Planning Commission Meeting

Wednesday, January 22, 2025 at 6:00 PM

MEETING DATE:	January 22, 2025
PROJECT:	CVS (Store 2745) at May River Crossing - Certificate of Appropriateness-Highway Corridor Overlay District (HCO)
PROJECT MANAGER:	Charlotte Moore, AICP Principal Planner

MEETING DATE:	January 22, 2025
PROJECT:	Culver's Bluffton Preliminary Development Plan
APPLICANT:	William Heintz, Kimley-Horn
PROJECT NUMBER:	DP-10-24-019406
PROJECT MANAGER:	Dan Frazier Planning Manager Department of Growth Management

TITLE: PHOTOMETRIC SITE PLAN

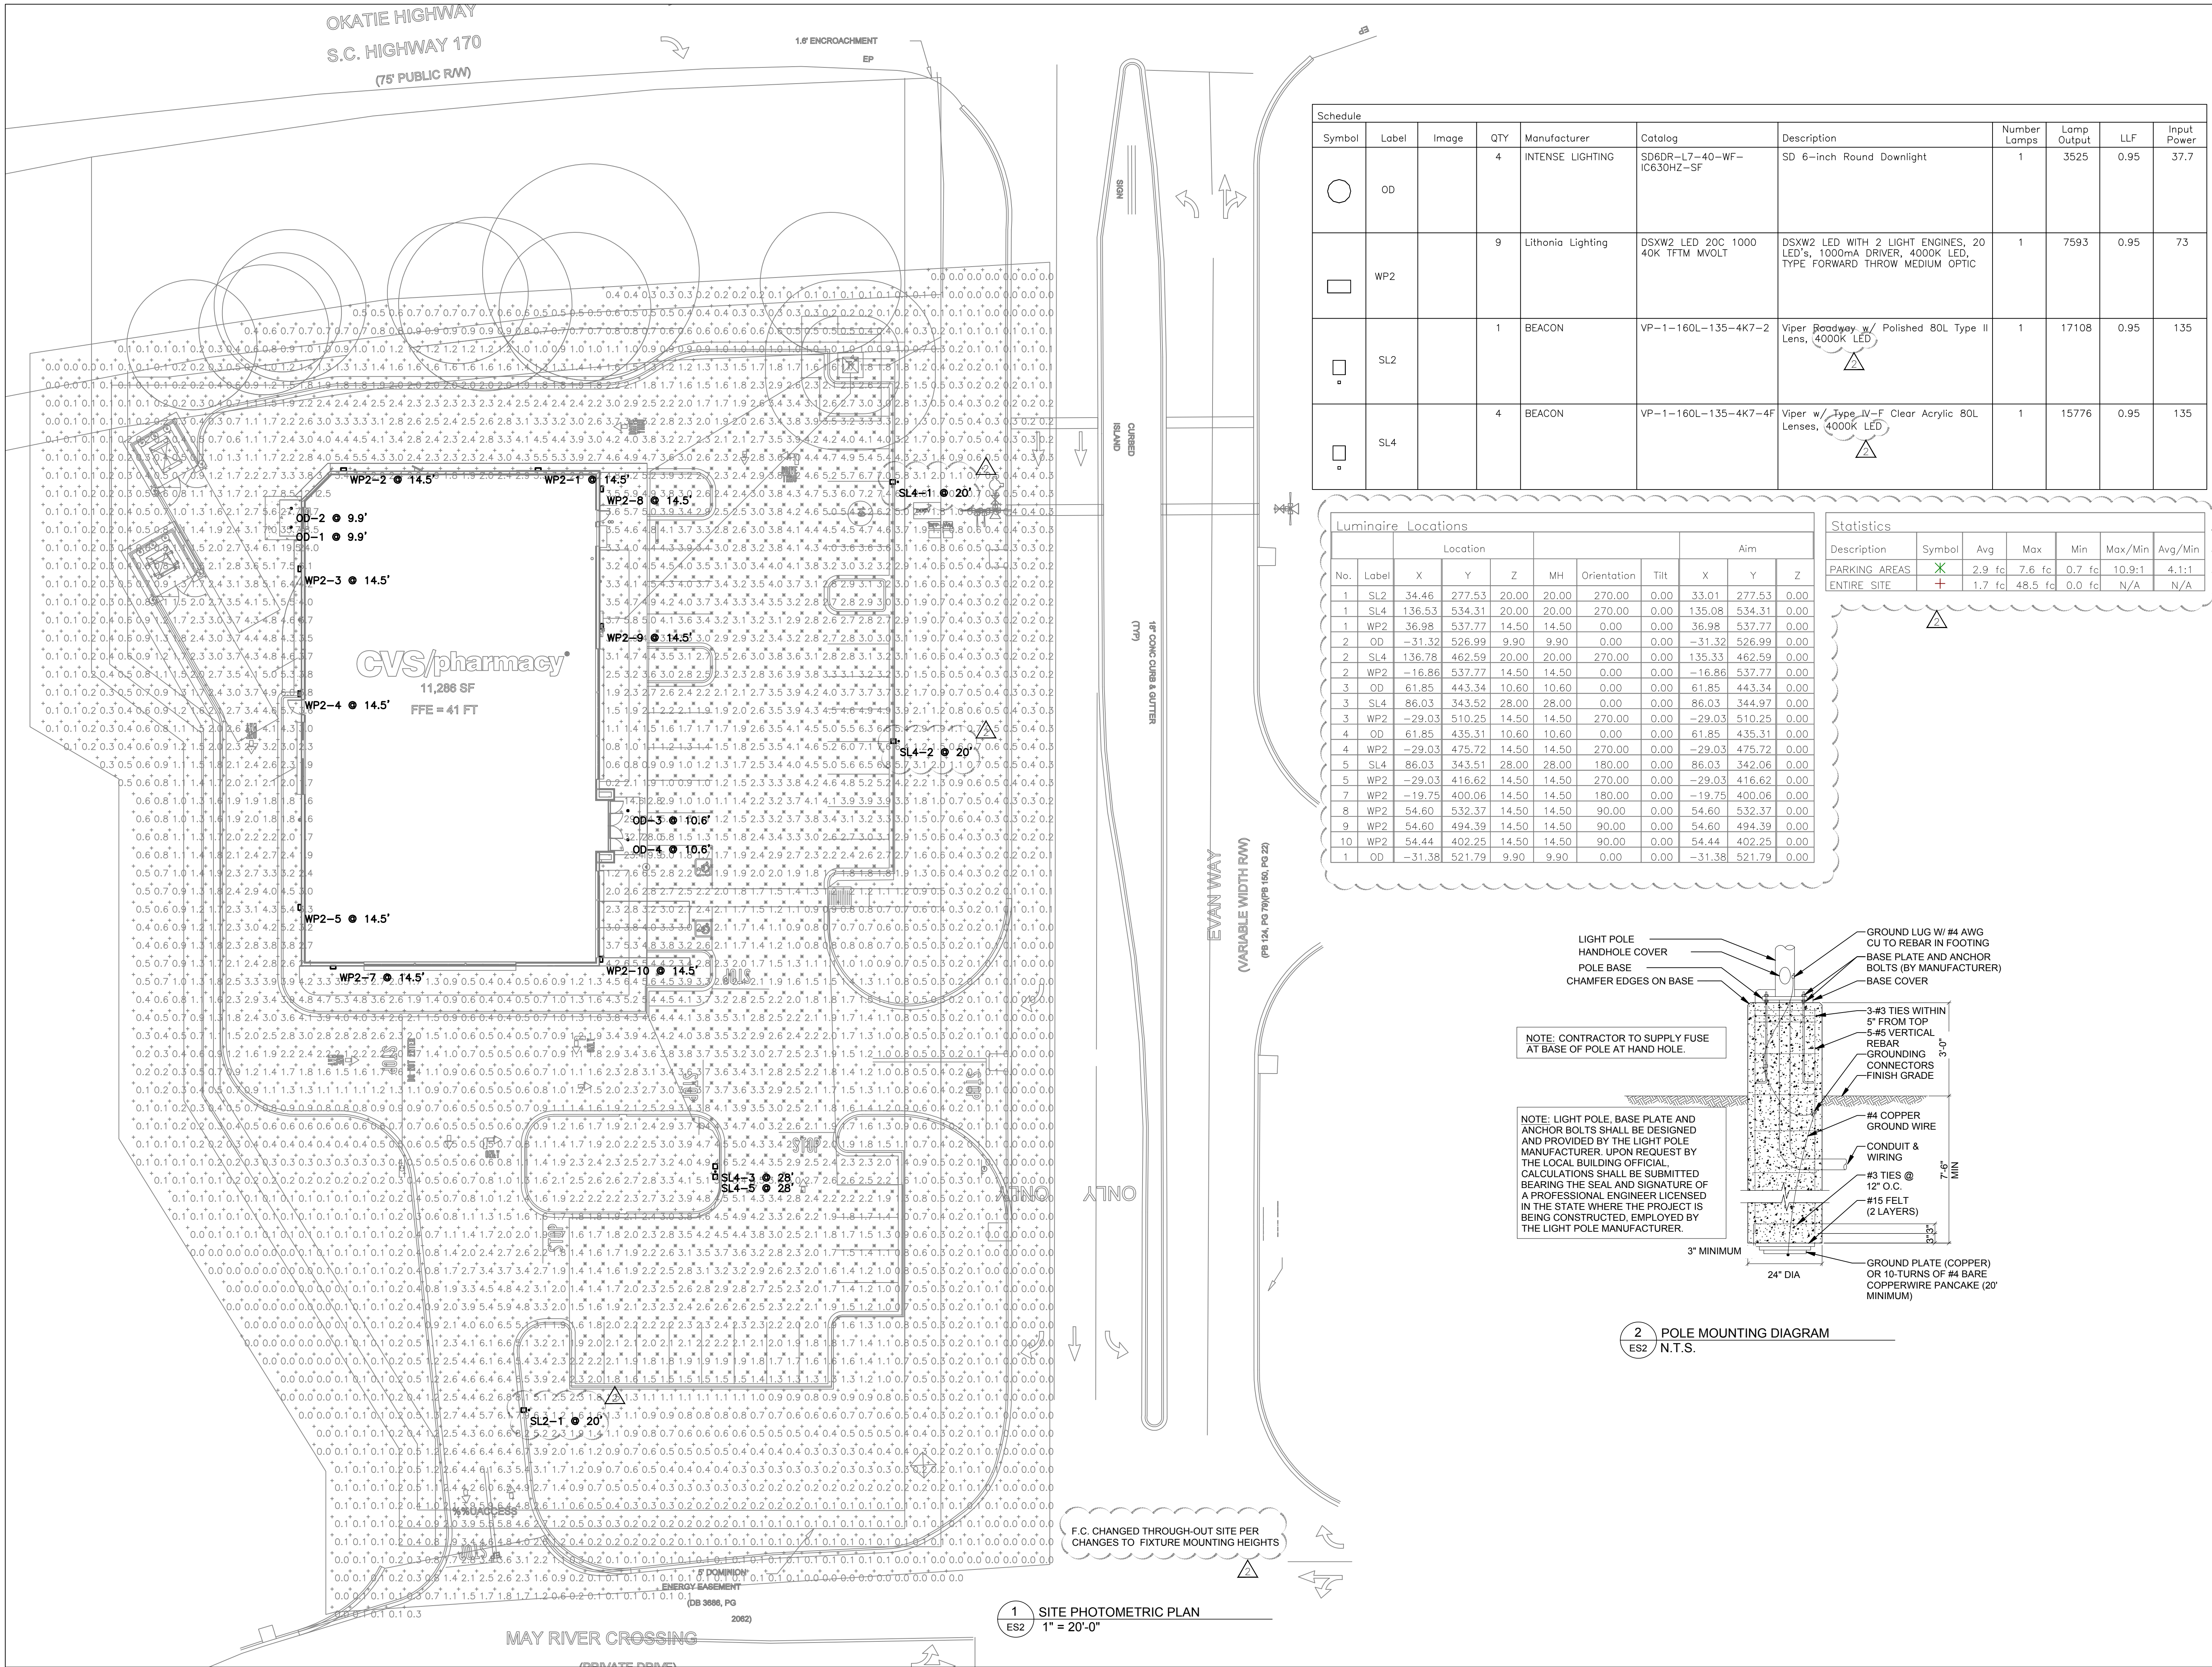
- b. **Finding – Light Source (Lamp).** Per Section 5.15.11(E)(2), only incandescent, fluorescent, metal halide, mercury vapor or color corrected high-pressure sodium light may be used. The same type must be used for the same or similar type of lighting on any one site. The Applicant proposes the use of LED luminaries in the parking area and for the wall pack lighting on the building. As such, the Planning Commission must determine the appropriateness of the use of LED lighting as a substitute for those listed in Section 5.15.11.

16. Illumination Levels -Show illumination levels for the various site areas that are consistent with Sec. 5.15.11(E)(4)b.

- a. Refer to revised site lighting / photometric plan for illumination revisions.
